MISSISSIPPI POWER & LIGHT COMPANY

SUBJECT: Grand Gulf Nuclear Station
Units 1 and 2
Docket Nos. 50-416 and 50-417
File 0260/0862
Transmittal of Proposed FSAR
Changes and Responses to NRC
SER Open Items
AECM-81/324

This information represents proposed changes and additions to the Grand Gulf Nuclear Station Final Safety Analysis Report (FSAR).

Figure 1

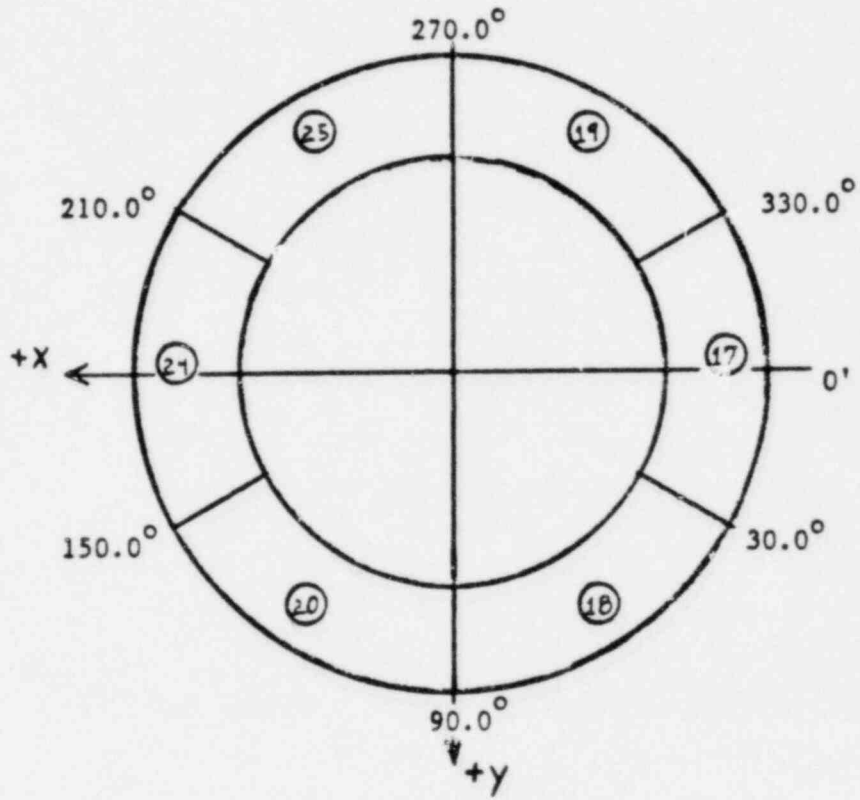
- b) As shown in FSAR Figure 6.2-26a, the annulus between elevations 163.9' and 173.3' is divided equally into six subcompartments; 17, 18, 19, 20, 24 and 25. Table 6.2-15a shows the volumes of these subcompartments to be equal. Figure 1 (attached) illustrates the orientation of these subcompartments with respect to the coordinate axes. The force coefficients for each subcompartment are calculated by projecting the circumferential area subtended by the subcompartment on the axes of the pressure vessel and the sacrificial shield. Tables 6.2-17a, b, and 6.2-18a, b erroneously show the χ component force coefficients for subcompartments 20 and 24 to be reversed for the RPV and Sacrificial Shield for both the Recirculation Inlet and Recirculation Suction Line Break analyses. That is, the coefficient reported for subcompartment 20 should be that of subcompartment 24 and the coefficient reported for subcompartment 24 should be

that of subcompartment 20. Tables 6.2-17a, b and 6.2-18a, b have been revised accordingly. The force and moment calculations for both the reactor pressure vessel and the sacrificial shield for the Recirc Inlet and Recirc Suction line breaks have been re-examined. It has been determined that the effect of this error on the total forces and moments is negligible.

Figure 2
Sign Convention for Force and Moment

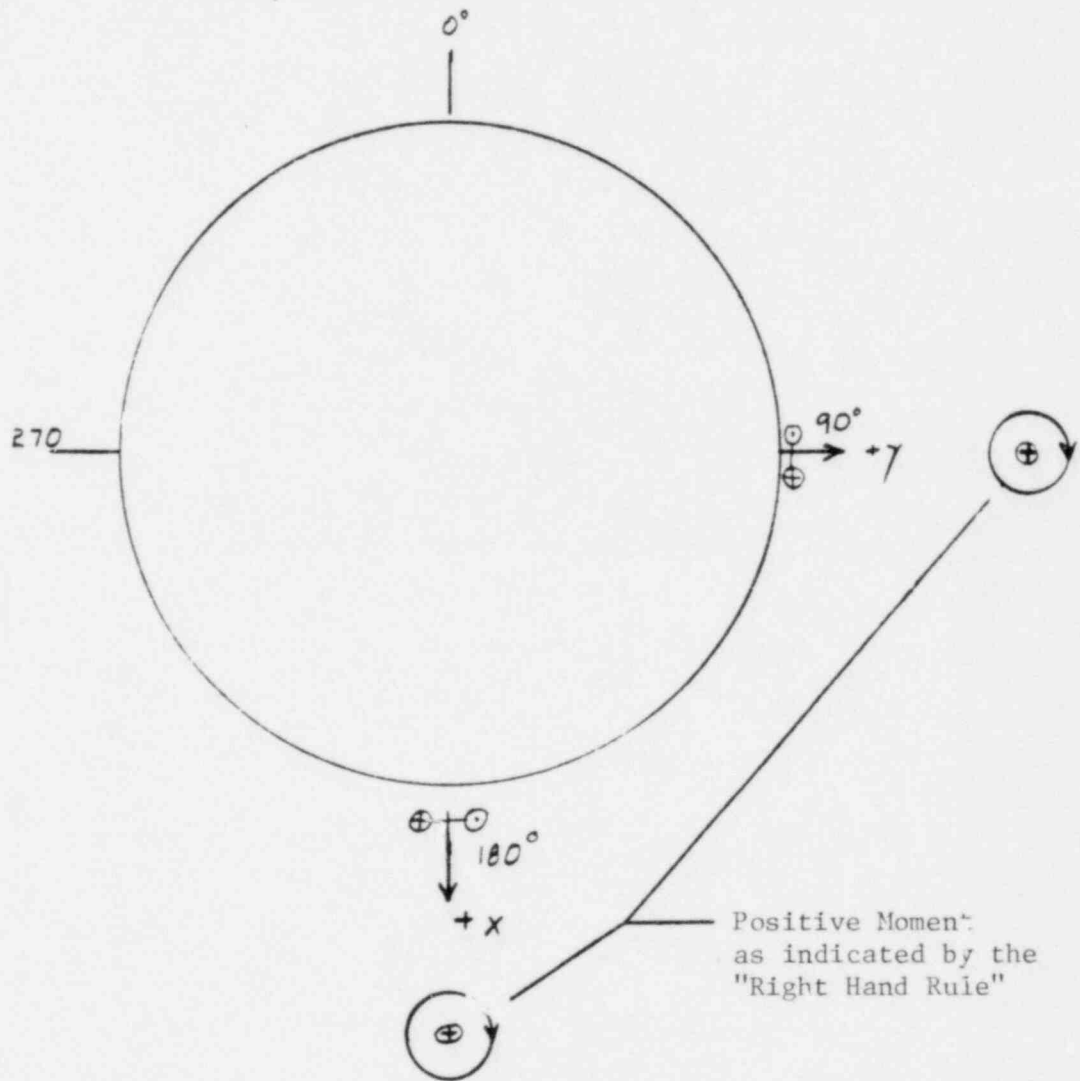
- c) The plots of force vs. time for the reactor pressure vessel and the sacrificial shield, shown in FSAR Figures 6.2-28aa, et al and 6.2-29aa, et al, respectively, are labelled "FORCE X" or "FORCE Y". The label "FORCE X" is used to describe the force calculated in the X direction and the label "FORCE Y" is used to describe the force calculated in the Y direction. (See Figure 2 attached)

The plots of moment vs. time for the reactor pressure vessel and the sacrificial shield, shown in FSAR Figures 6.2-30aa, et al and 6.2-31aa, et al are labelled either "MOMENT X" or "MOMENT Y". The label "MOMENT X" is used to describe the moment due to the force in the X direction and the label "MOMENT Y" is used to describe the moment due to the force in the Y direction.

FIGURE 6.2 - 25c

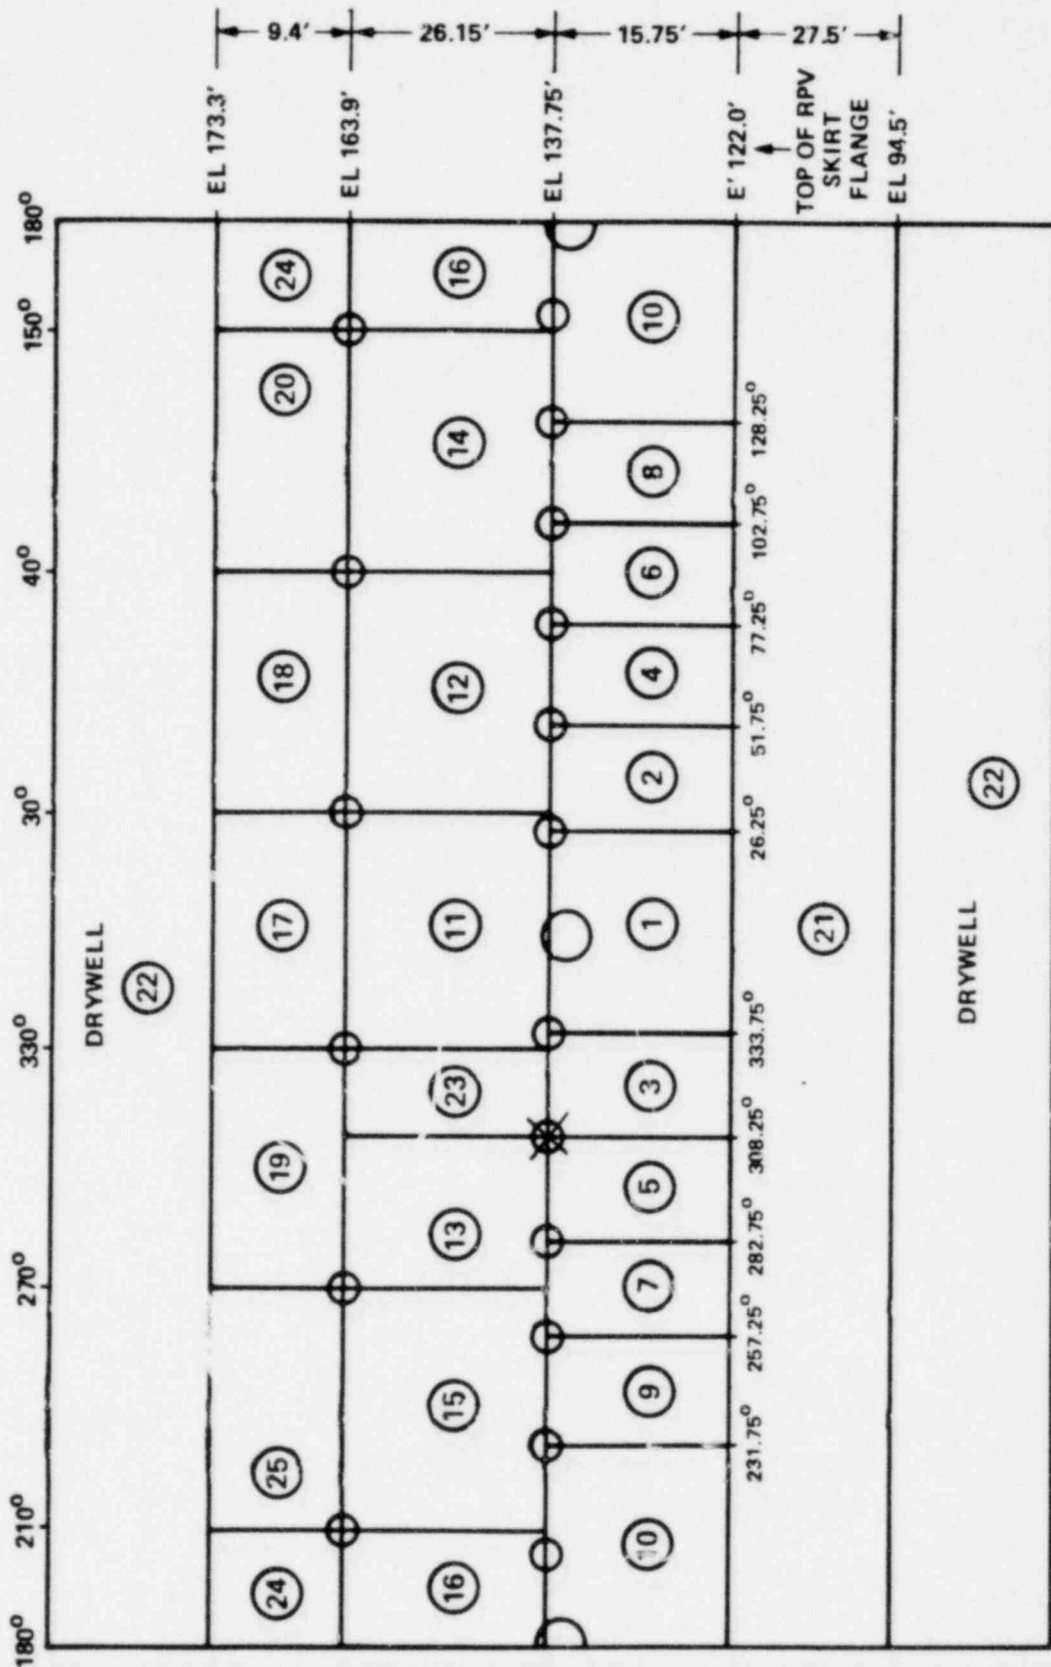
FSAR Table 6.2-16c and Figure 6.2-25c were both found to be incorrectly showing a flow path #51 between subcompartment 25 (the flow diverter) and subcompartment 24 (in the annulus).

Since there is no direct flow path between these two subcompartments and since none was assumed for the Feedwater Line Break analysis, the above mentioned Table and Figure have been revised without impacting the results of the analysis.

FIGURE 6.2 - 30aa

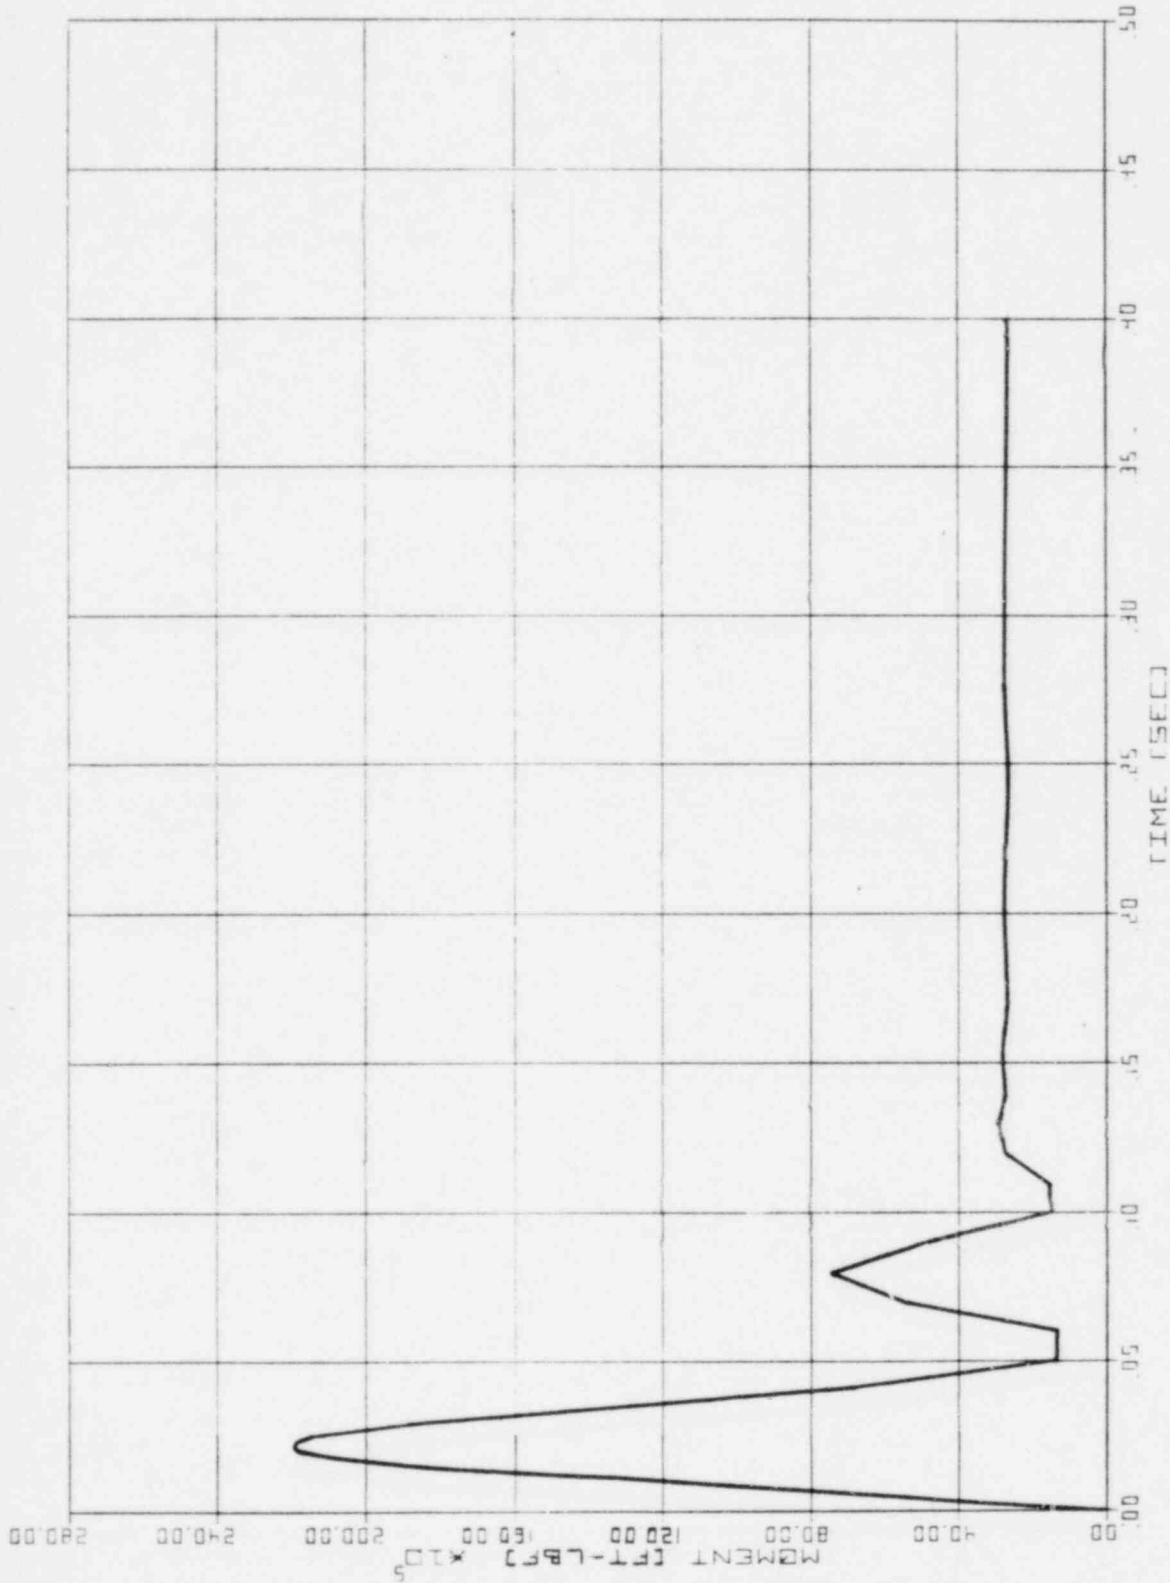
- a) Figures 6.2-33a, b and c for the Recirculation Inlet Line, the Recirculation Suction Line and the Feedwater Line respectively show that the load center elevation for the nodes on the third level is at 168.6'. If the reference elevation for moments is at 121.33', this would indicate that the moment arm for the subcompartments on the third level would be 47.27 ft. Tables 6.2-17 a, b, and c and 6.2-18a, b, and c have been revised accordingly.

The force coefficients and moment arms given in FSAR Tables 6.2-17a, b and c and 6.2-18a, b and c were used to calculate the moments shown in FSAR Figures 6.2-30aa, ab, ba, bb, ca, and cb and 6.2-31aa, ab, ba, bb, ca and cb. The incorrect moment arm for the third level of subcompartments in the annulus was used in the calculation of the values plotted in the above mentioned Figures. Therefore, these plots have been redrawn using the correct moment arm in the calculations of moments.

The moment arm values given in FSAR Tables 6.2-17a, b, and c and 6.2-18a, b, and c, and the plots shown in FSAR Figures 6.2-30aa, ab, ba, ca, and cb and 6.2-31aa, ab, ba, bb, ca, and cb are presented for the purpose of illustration. The values of the moments given in FSAR Figures 6.2-30aa, et al and 6.2-31aa, et al were not used in any design calculations. Therefore, the above mentioned corrections have no impact on the design of the plant or any equipment.
